ALTERNATOR WITH AUTOMATIC ADVANCE RETARD / SS, SX-175, 250

1976 and later SS/SX-175, 250 motorcycles built in Italy, starting with the following vehicle identification numbers, are equipped with automatic ignition advance/retard feature to improve starting and to eliminate kickstarter lever kickback.

ALTERNATOR FLYWHEEL ROTOR - ILLUSTRATION A

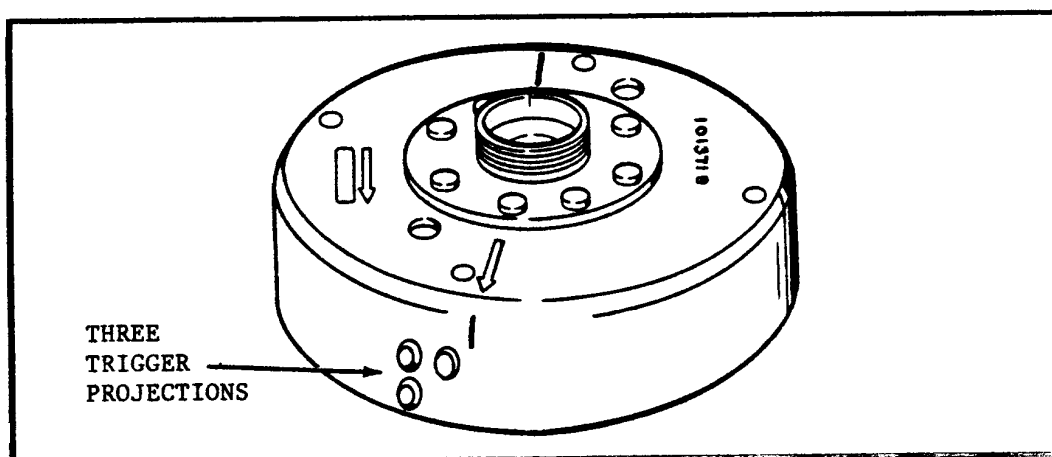
Also, some York produced 1976 motorcycles incorporate this feature. To aid in identifying these motorcycles, the flywheel rotor has three trigger projections on the outer diameter instead of two as on previous models. See illustration A.

ROTOR AND PICK-UP TIMING MARKS - ILLUSTRATION B

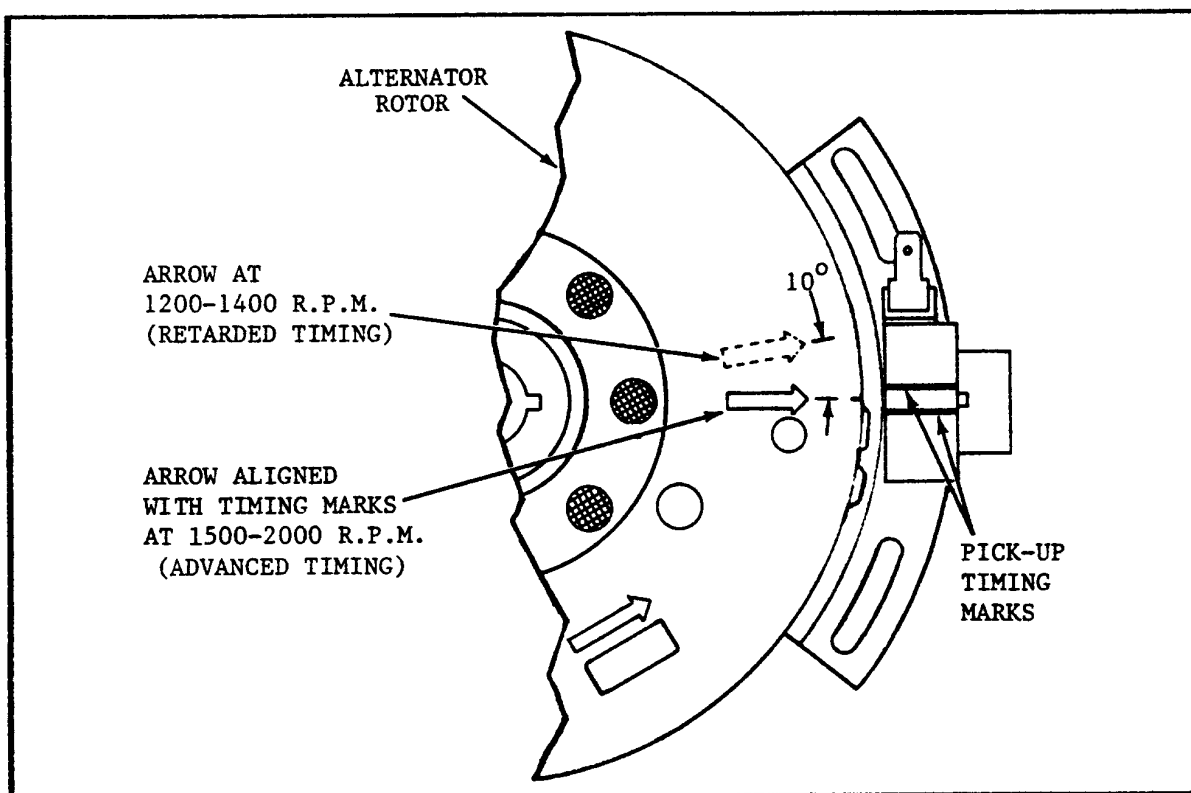
2. Connect timing light and start engine. With engine running at a slow idle (1200-1400 rpm), timing arrow on rotor should not be aligned with timing marks on pick-up, but rotated about 10 degrees in a counterclockwise direction. With gradual acceleration to 1500-2500 rpm, arrow on rotor should instantly align between pick-up timing marks. See illustration B. If speed is increased to 7500 rpm, the arrow should remain in position without any variation.

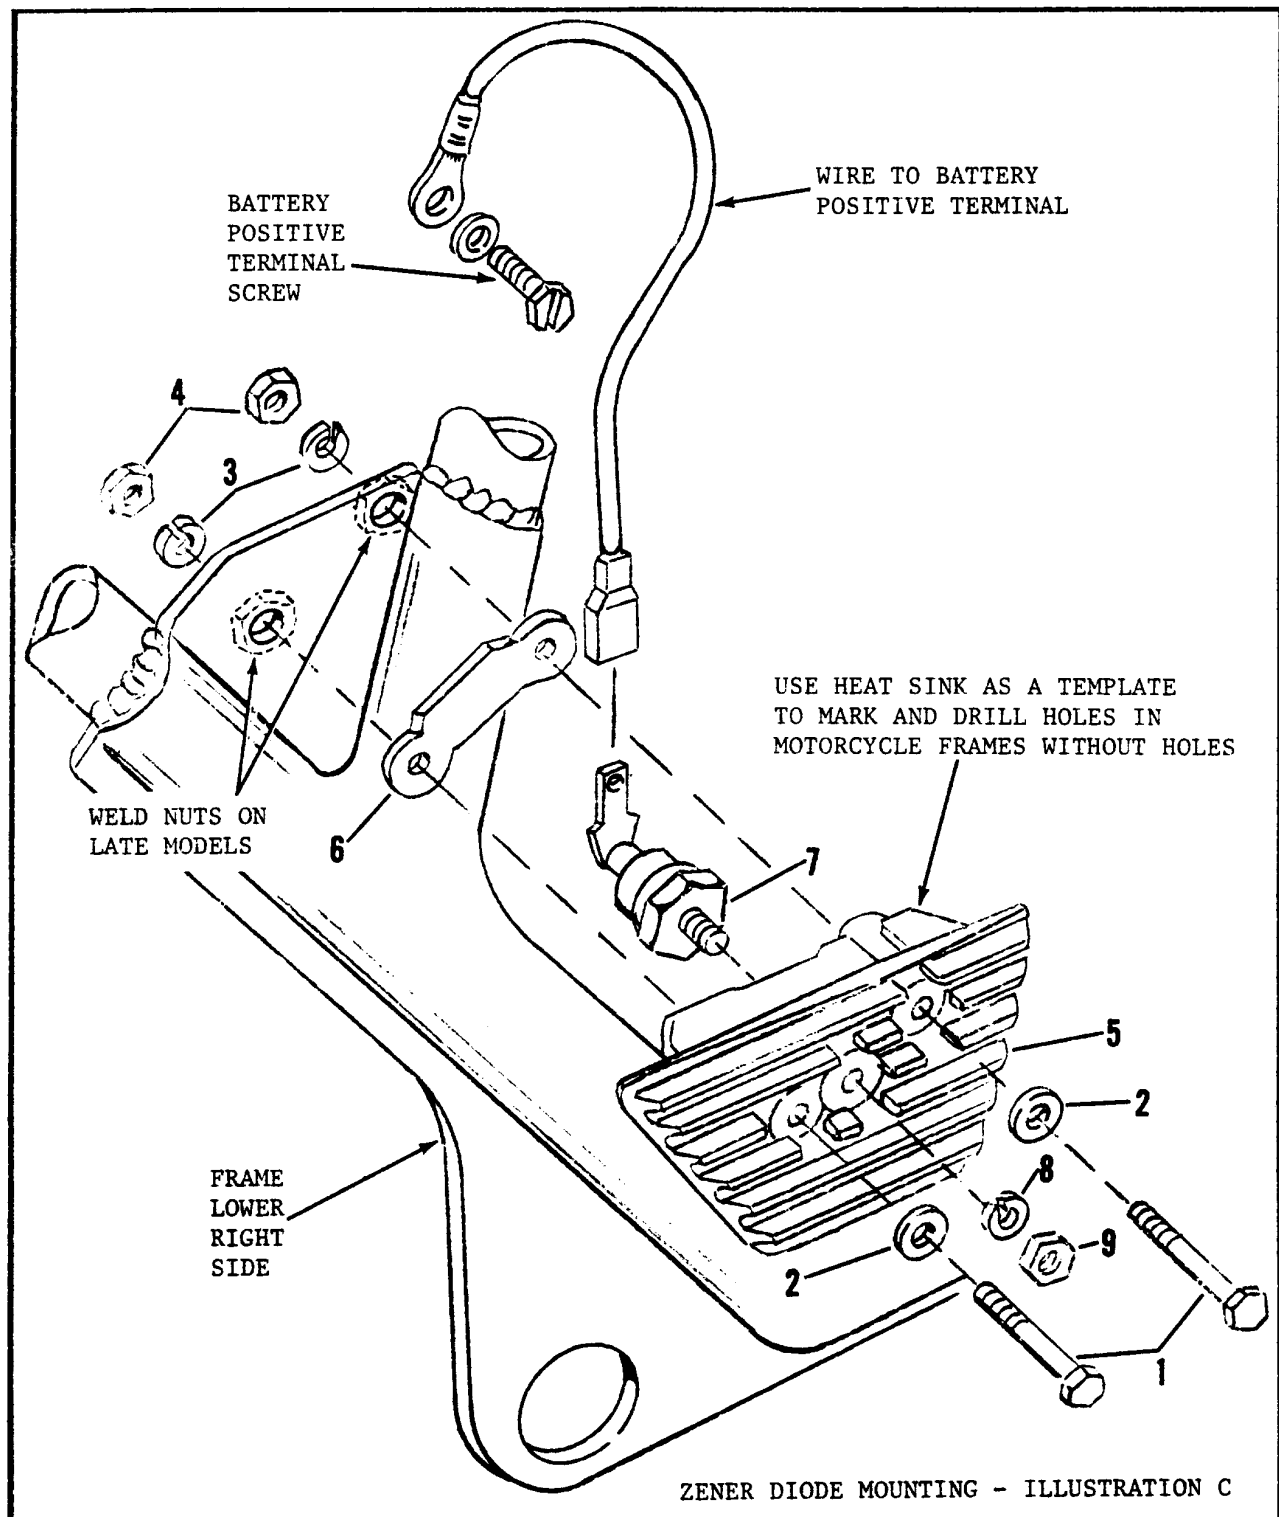
Note: This rotor has a higher output than the earlier type rotors and if installed on an earlier model it requires a zener diode with heat sink in the electrical system to limit voltage.

The 1976 and later models involved may or may not have a zener diode already installed in one of the two locations. One location is underneath the front fork tube lower bracket below the head lamp. The other location is on the frame bracket just outside the battery on the right side of the motorcycle. If the new rotor is used and there is no zener diode, one should be installed on the frame using the following parts: (See illustration C)

The heat sink and diode assembly should be mounted on the frame using the bolt holes provided in the bracket located just outside the battery on the right side of the motorcycle. Connect the wire to the diode terminal and the battery positive (+) terminal.
